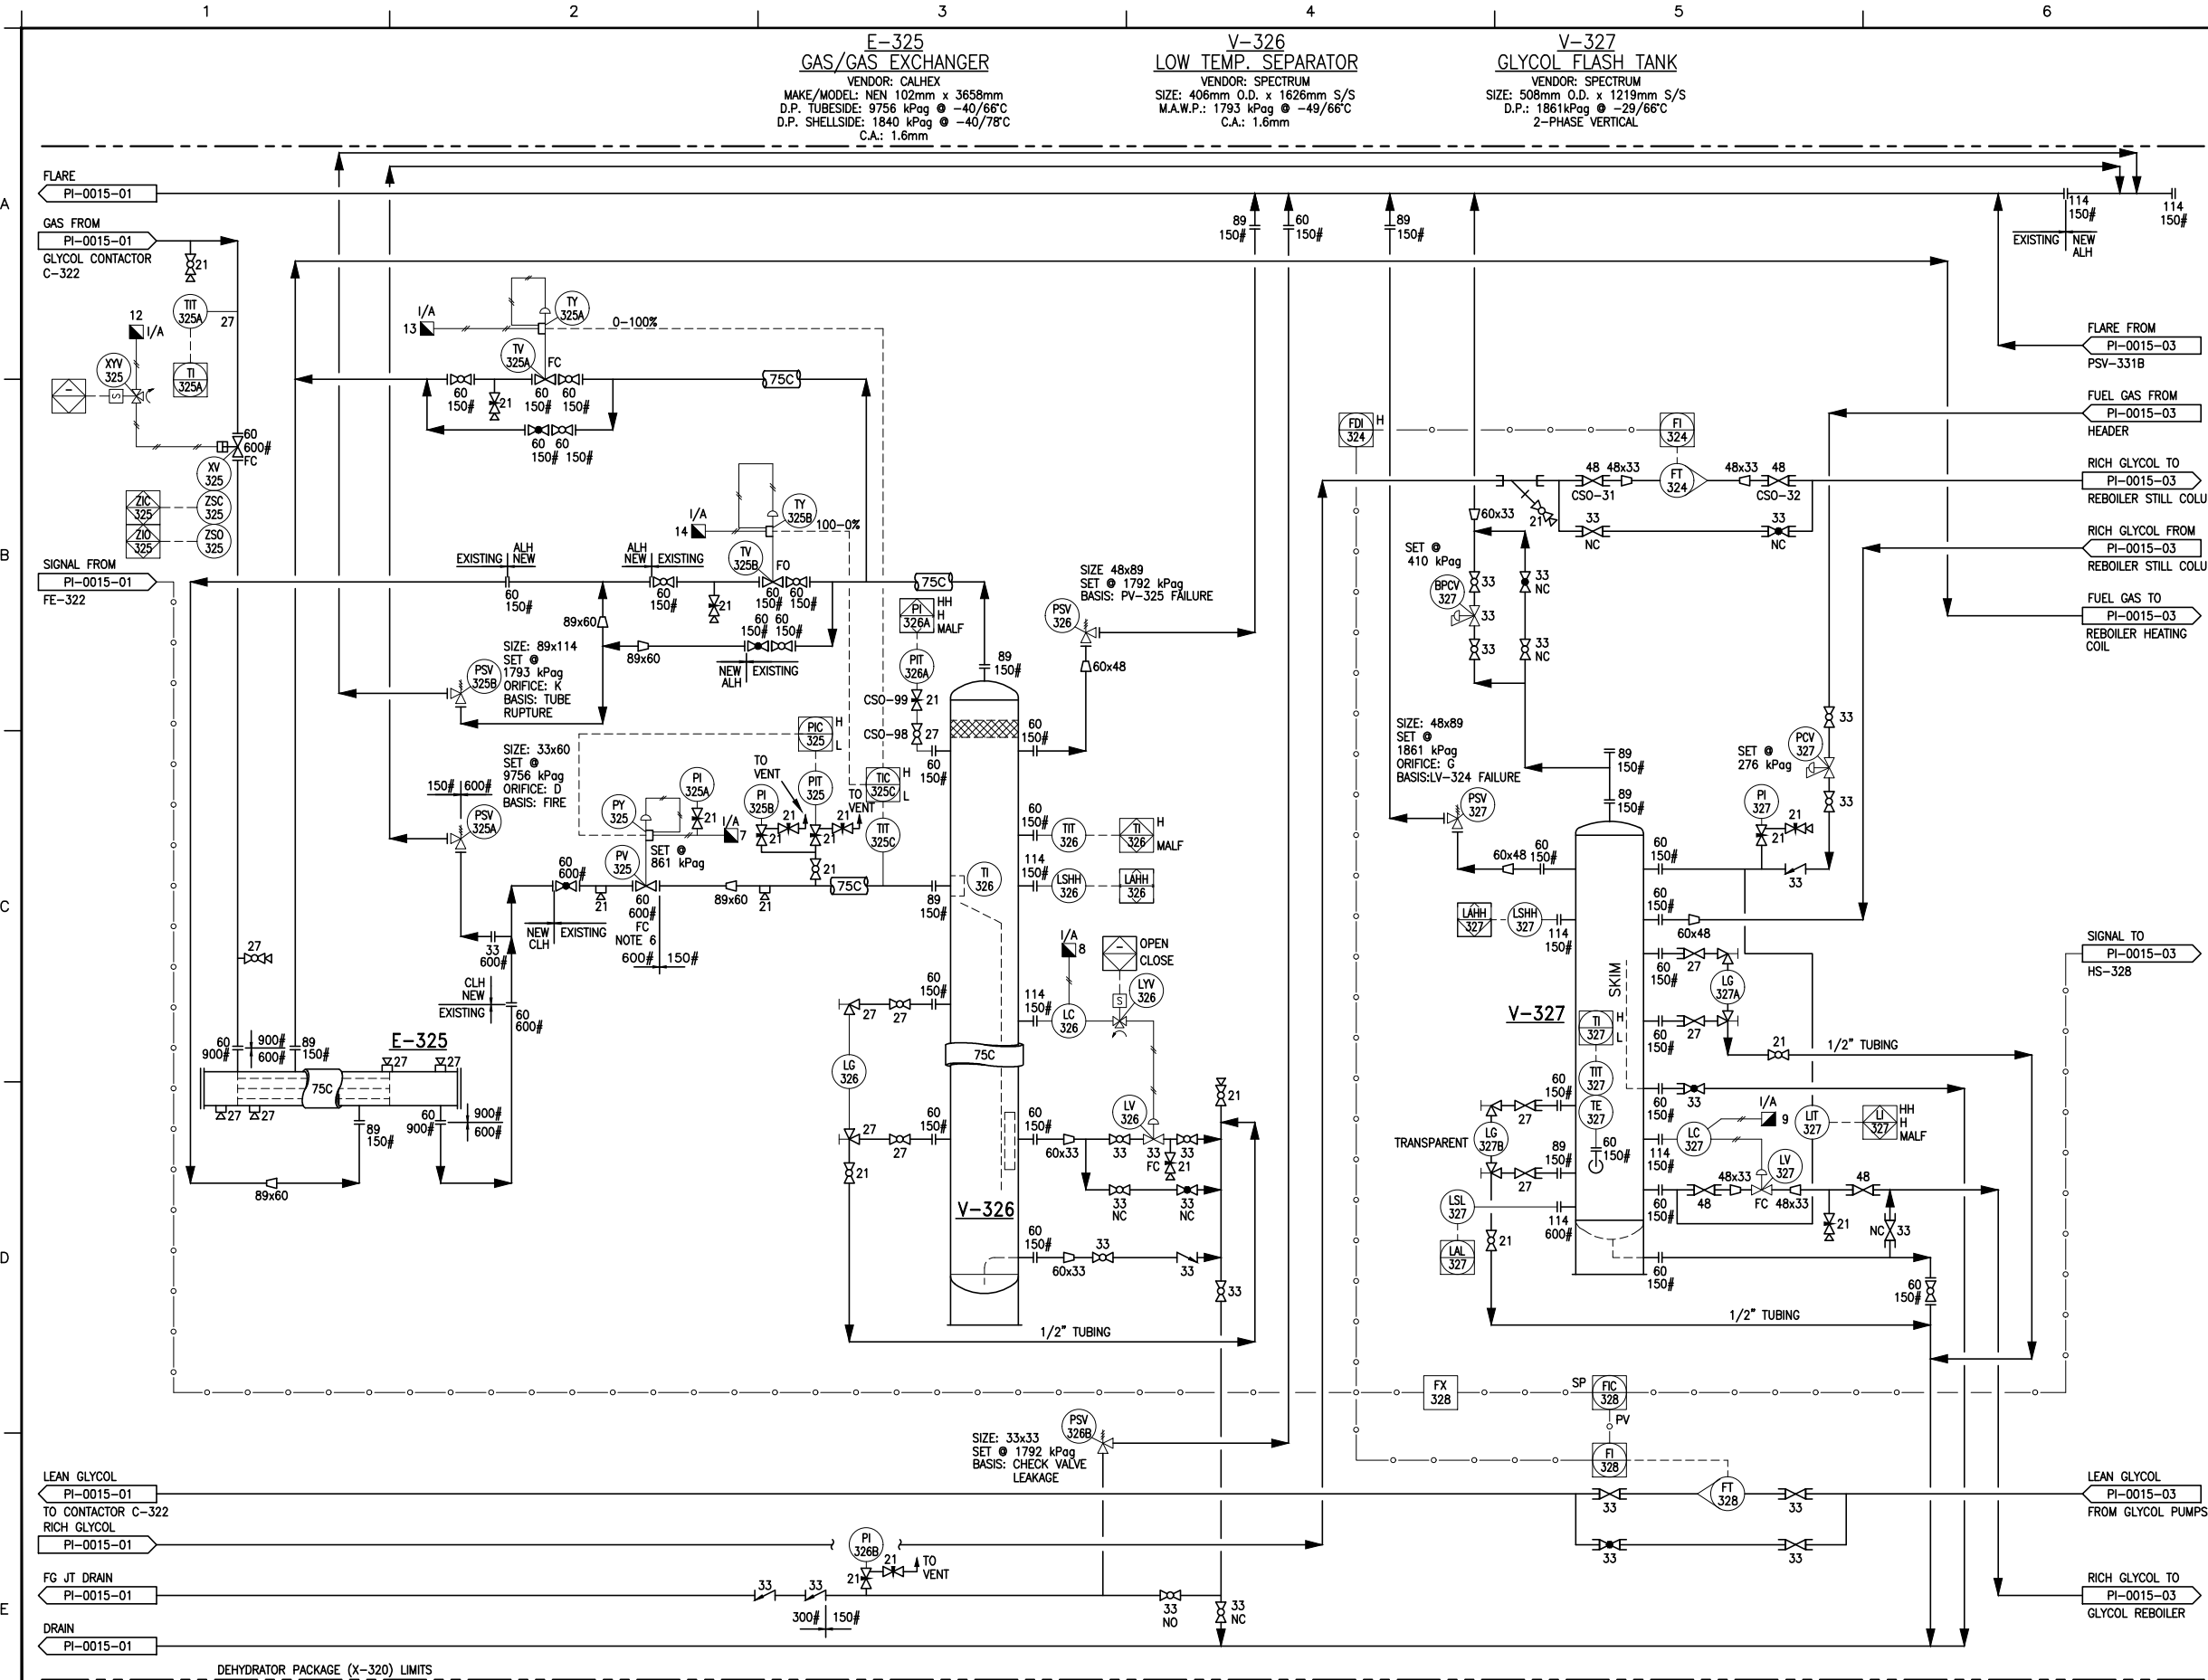
- NOTES**
- * NOTES RENUMBERED TO INCORPORATE TYPICAL PIPING NOTES 1 TO 4.
 - 1. ALL PROCESS & INSTRUMENT VENTS SHALL BE AT LEAST 500mm FROM ANY ELECTRICAL CONNECTION OR OUTLET.
 - 2. INSULATE ALL A/G PIPE AND FLANGES WHERE SPECIFIED WITH FIBERGLASS INSULATION AND ALUMINIUM CLADDING.
 - 3. ▲ DENOTES VENDOR SUPPLIED ITEMS WHERE O/S OF PACKAGED UNITS.
 - 4. FIELD TO SUPPLY VENTS AND DRAINS AS REQUIRED.
 - 5. VENDOR PACKAGE P&ID WILL BE STAMPED BY VENDOR, FOR PURPOSE OF THIS DRAWING, ENGINEERING STAMP VERIFIES THAT THE VENDOR PACKAGE DRAWING (AS SHOWN) IS IN COMPLIANCE WITH THE HUSKY ENERGY HAZOP MEETING REQUIREMENTS AND RECOMMENDATIONS.
 - 6. PROCESS RECOMMENDS CHANGING TRIM SIZE FROM 1/4" TO 3/8". THIS TRIM SIZE CHANGE IS TO MAKE THE VALVE OPERATE AT 73% OPEN INSTEAD OF 92% OPEN.
